*Port MacKenzie Rail Extension Project  
Iditarod Dog Sledding Historic District Workshop Summary  
and Implementation Plan*

**DRAFT**

March 1, 2012

Figure 3: Constraints

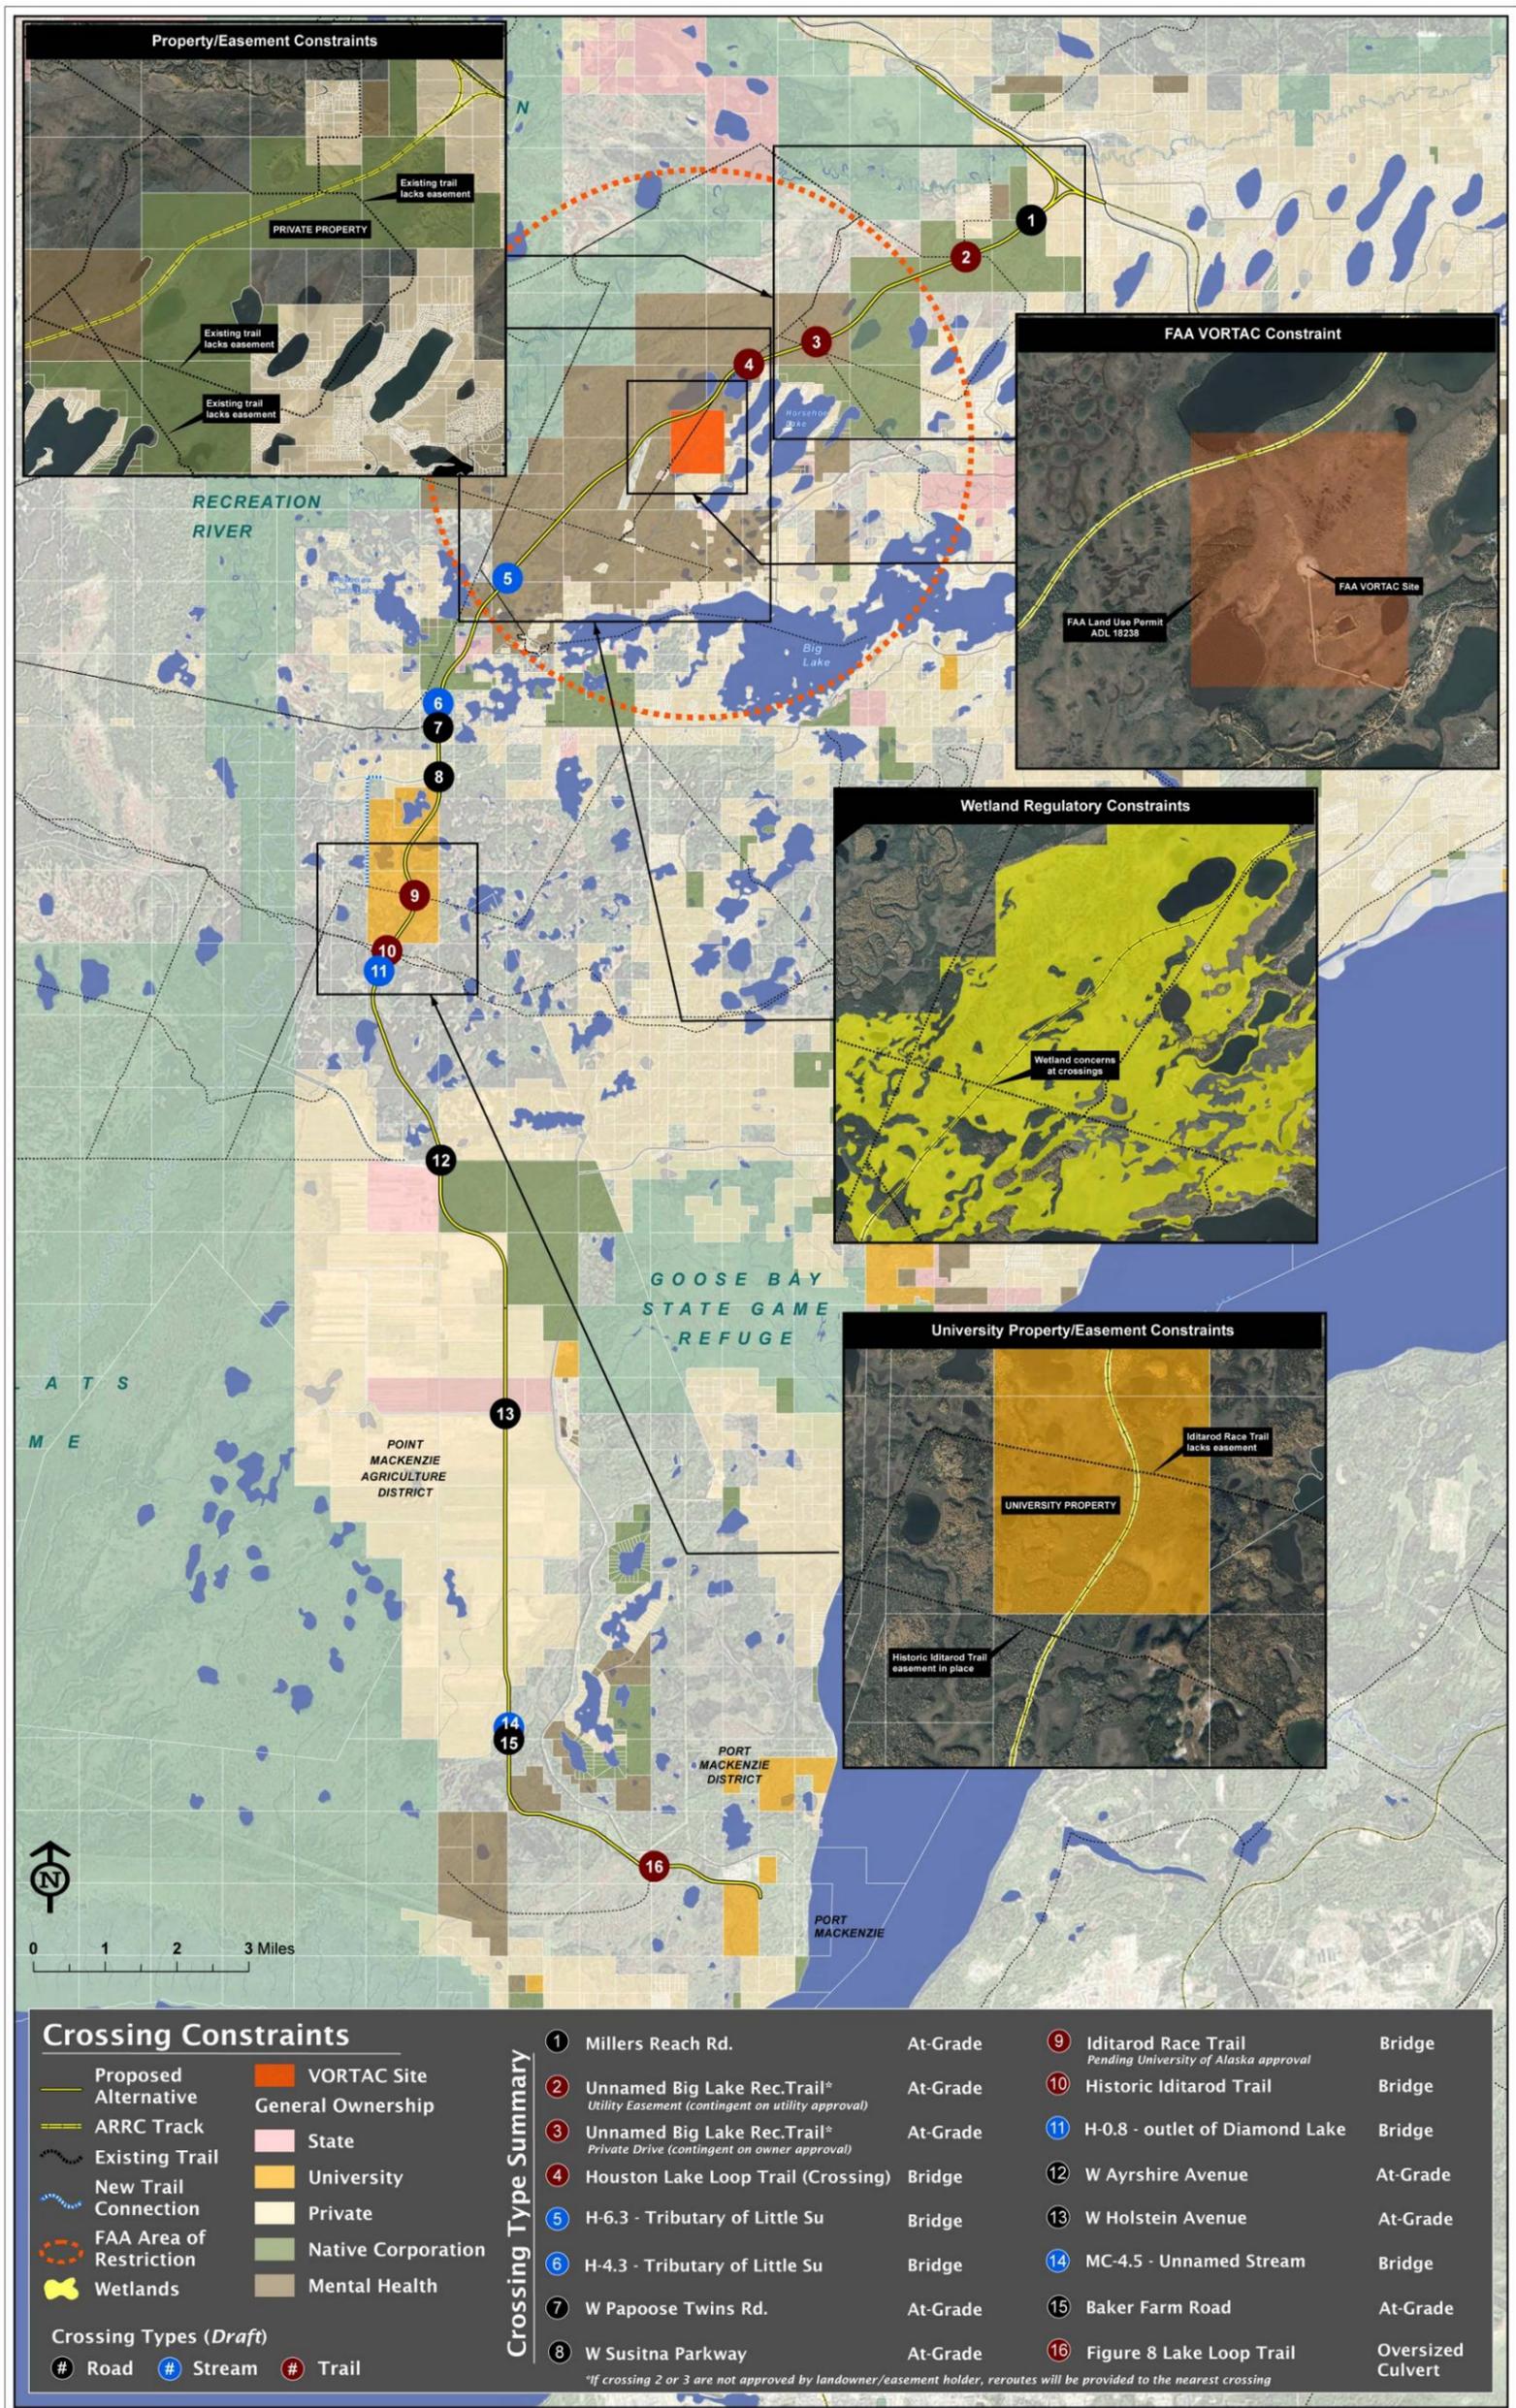
Wetland complexes between Crossings 4 and 6 have made adding crossings difficult (see Attachment A, Figure 3). In consultation with the Project Team, the Corps and EPA requested that there be no increases in the project footprint in wetlands areas to accommodate a widened embankment area. As a result, the Project Team has worked to keep the rail embankment as low as possible in wetlands areas to minimize impact. In the case of the Iron Dog Connector Trail (an officially recognized trail), adding a grade-separated crossing would require raising the embankment high enough to provide 12' to 14' of clearance for trail users and would increase the fill footprint of the embankment over several miles. Adding an at-grade crossing would increase the impact to wetlands as the crossing would require additional embankment at the approaches to the proposed railroad crossing.

Land ownership and lack of legal easements are also challenges. The Project Team must consider property ownership when planning crossing locations, so as to not promote trespass or provide a crossing that may not be usable into the foreseeable future. This is a concern between Crossings 1 and 3 and Crossings 7 and 10 (see Attachment A, Figure 3). The MSB is currently
